Interoffice Memorandum

SUBJECT: March 12, 2019 – Public Hearing
Shoreline Alteration/Dredge and Fill Permit Application
(After-the-Fact) for Mark and Amy Brown (SADF-17-11-019)

After-the-Fact
Shoreline Alteration/Dredge and Fill
Permit Application Request
District #2

Shoreline Alteration/Dredge and Fill
Permit No.: SADP-17-11-013

Project Site

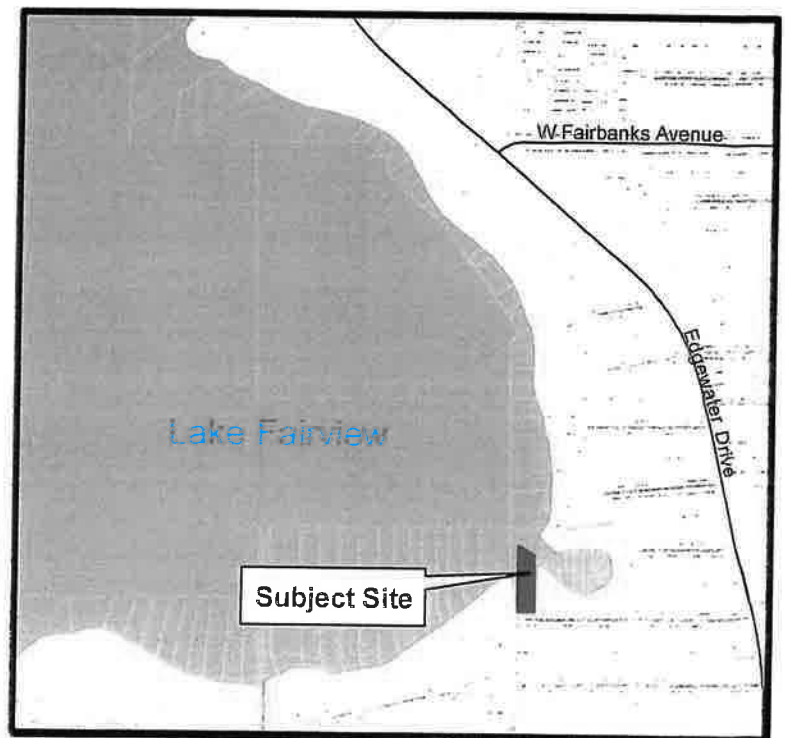
The applicants are requesting a permit to authorize an existing vinyl seawall measuring approximately 175 linear feet. The western portion of the seawall is located on Lake Fairview and the northern portion of the seawall is located on the Lake Fairview Canal. Riprap and aquatic plantings will be installed on the lakeward portion of the seawall, but not on the canal-front portion so as not to cause a navigation issue.

2. Riprap and plantings shall be installed along the portion of the seawall fronting Lake Fairview in accordance with the plans submitted by Structural Engineering Services, Inc., received by Environmental Protection Division (EPD) on November 30, 2018.

3. Riprap shall be installed at a 2 (horizontal): 1 (vertical) slope, and extend at least halfway up the face of the seawall.
4. The installation of riprap must commence within 60 days and be completed within 90 days from the date of issuance of the permit. In the event that installation of the riprap has not commenced within 60 days or been completed within 90 days this permit is void and a new permit application with fee will be required.

5. Installation of plantings must be initiated within 30 days of installation of the riprap. After one year, if 80% coverage of native species is not established, additional replanting may be required.
